10.0 Steam and Power Conversion System

The information in this section of the reference ABWR DCD, including all subsections, tables and figures, is incorporated by reference with the following departures and supplements.

Figure 10.1-1 Reference Steam and Power Conversion System

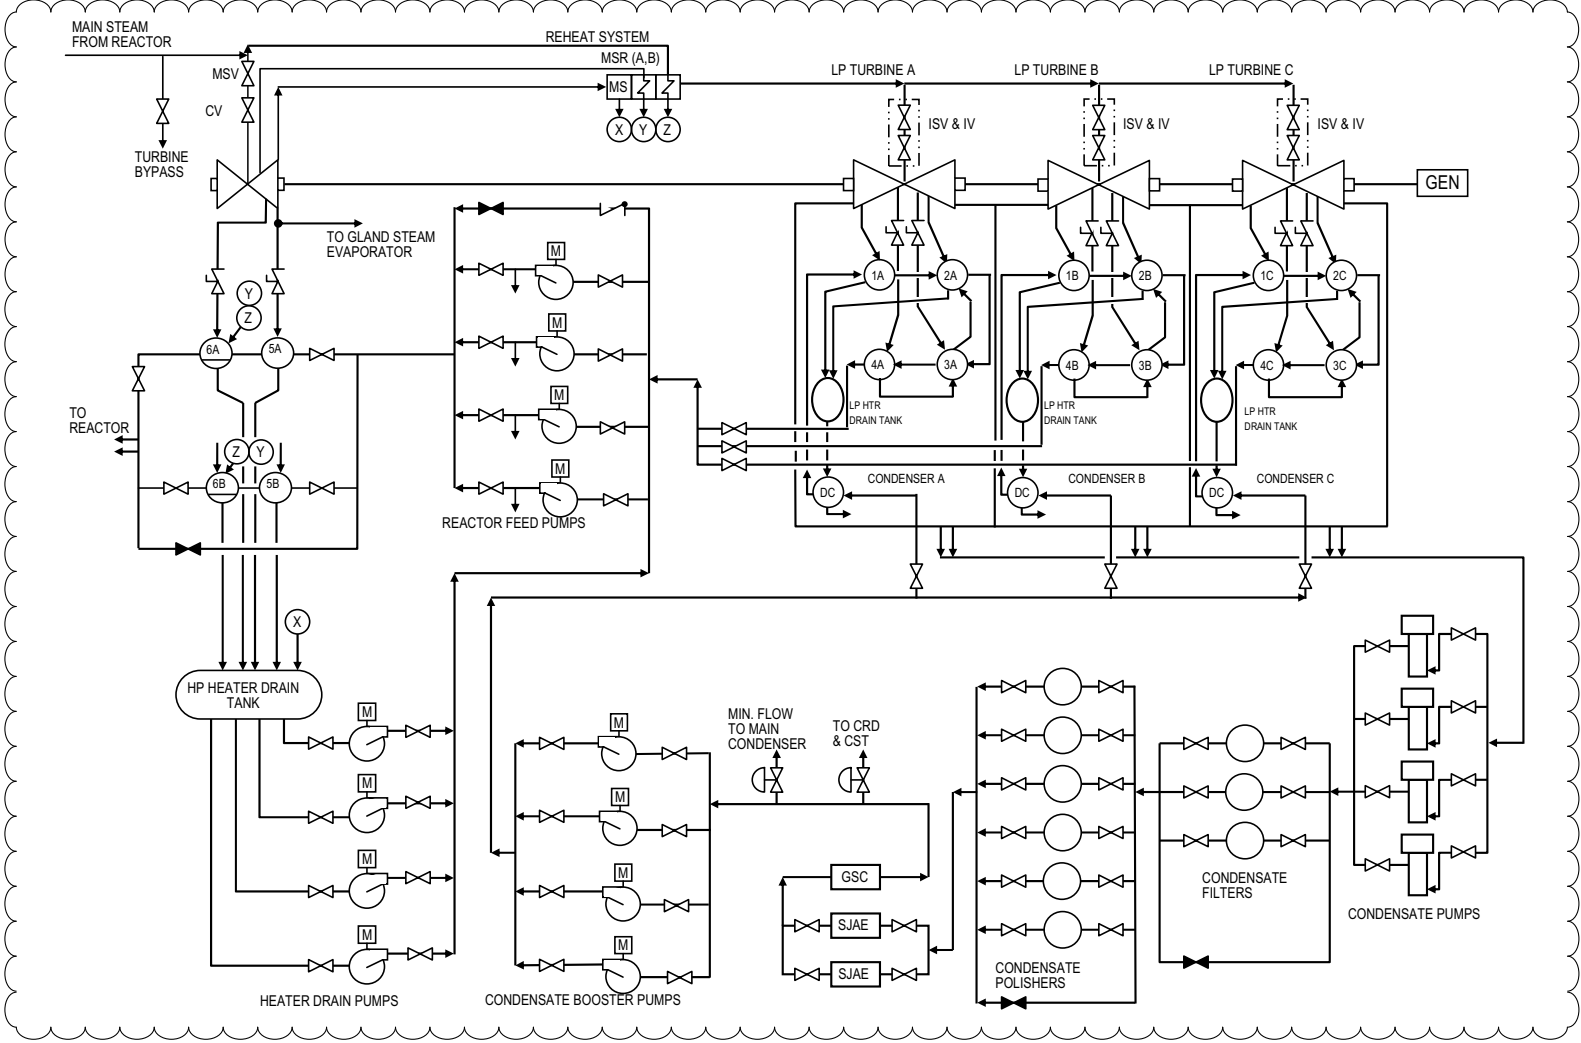
STP DEP 9.2-3 (Figure 10.1-1)

STP DEP 10.1-2 (Figure 10.1-1)

STP DEP 10.2-1 (Table 10.1-1, Figure 10.1-1)

Major S&PC System design features are summarized in Table 10.1-1. The system main ~~conceptual~~ features are illustrated on Figure 10.1-1, ~~assuming a triple pressure condenser. This type of condenser and other site dependent ABWR plant features and parameters are reported herein based on typical central U.S. site conditions. They are given here to more completely define the ABWR Turbine Island standard design and to be used as references in reviewing future ABWR plant specific licensing submittals, and confirming that such submittals are indeed consistent with the standard design. Nothing in the ABWR Standard Plant design is meant to preclude the use of a once-through cooling system and a single pressure condenser nor will such changes affect the Nuclear Island.~~
